Service Bulletin

Bulletin No.: PIT6493C

Subject: Wind Noise From Driver Front Door

7104678

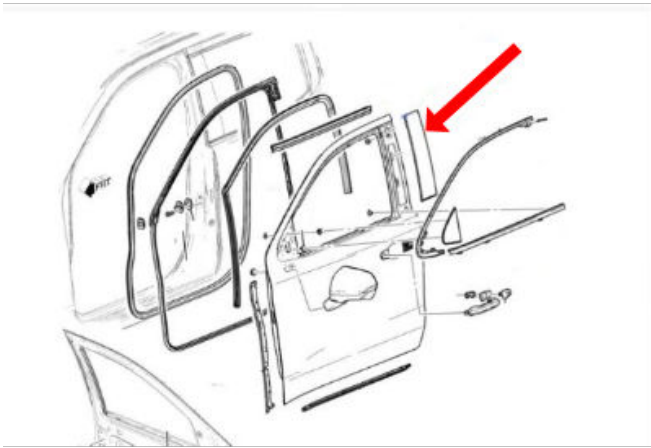
Involved Region or Country	North America
Condition	A customer may comment on hearing wind noise from the driver front door area while driving above 30 MPH.
Cause	The cause may be a gap between Front Side Door Window Frame Rear Applique and the Front Side Door Window Weatherstrip/Glass run channel (as shown below)

Verify the window run channel is fully seated into the door and adjust the Front Side Door Window Frame Rear Applique forward to close gap using the following procedure.

7111709

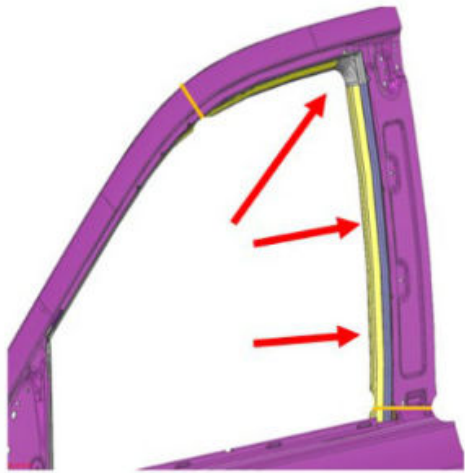
2. Ensure that the Front Side Door Window Weatherstrip is fully seated into the door metal run channel and that the rear upper molded-in alignment pin is fully seated into the square hole at the rear of the upper door opening (as shown below.) If the rear upper molded-in alignment pin is not seated in the hole or the weatherstrip is not fully seated in the channel, it will push the window weatherstrip forward creating a large gap between the weatherstrip and applique.

If weatherstrip or rear upper molded-in alignment pin is not fully seated, remove and reinstall the window weatherstrip. Reinstall the weatherstrip making sure the rear upper molded-in alignment pin is fully seated in the square hole in the door and that the weatherstrip is fully seated into the door metal run channel.

To seat the pin correctly, push the molded portion of the seal upward as far as possible, then rearward.
